Office Action Summary

10/724,964

This is a first office action for serial number 10/724964, entitled End Cap for Rain Gutters, filed on December 1, 2003.

FIG. 5

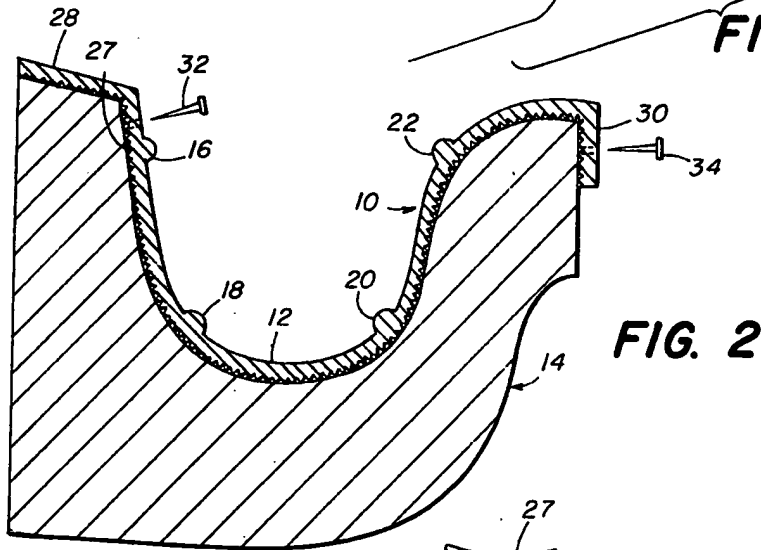
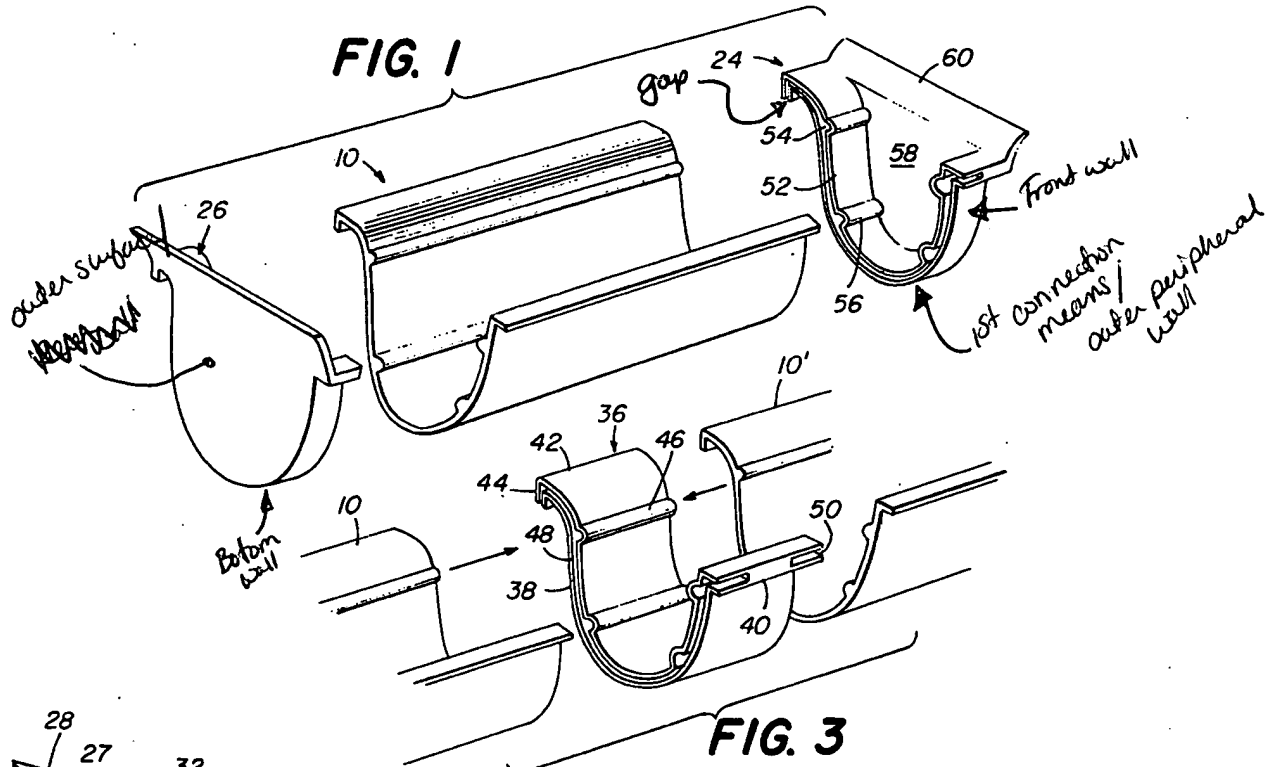
Carreiro discloses the claimed invention a rain gutter end cap (24, 26) comprising a) an end panel (60) having an inner surface (58) and an outer surface (attached figure 1) and including a perimeter having a predetermined shape (figure 1); b) first connection means (attached figure 1) carried by the end panel; and c) second connection means

(52) carried by the end panel; the first connection means (attached figure 1) includes an outer peripheral wall (attached figure 1 and at 60) extending laterally outwardly from the inner face (58) of the end panel and an inner peripheral wall (at 52) extending laterally outwardly from the inner face (58) of the end panel and positioned inwardly of the outer peripheral wall to define therebetween a connection slot (54); the outer peripheral wall defines an end cap top wall (where 60 points to), an end cap rear wall (attached figure 1), an end cap bottom wall (attached figure 1), and an end cap front wall (attached figure 1); the outer peripheral wall is substantially continuous (figure 1); the outer peripheral wall (attached figure 1) and the inner peripheral wall (at 52) are substantially perpendicular to the end panel inner surface (58); the outer peripheral wall includes a gap (attached figure 1) between the end cap top wall (at 60) and the end cap rear wall (attached figure 1); the inner peripheral wall (at 52) extends substantially along and parallel to the end cap front wall (attached figure 1), the end cap bottom wall, and the end cap rear wall (where 24 points to); wherein the inner peripheral wall (at 52) extends along the end cap rear wall (where 24 points to) from a point between the end cap top wall (at 60) and the end cap bottom wall (attached figure 1), along the end cap bottom wall, and along the end cap front wall to a point between the end cap top wall (at 60) and the end cap bottom wall (attached figure 1); the second connection means (52) includes at least one aperture (54) in the end panel; the second connection means (52) includes a projection (56) extending outwardly from the end panel inner surface (58).
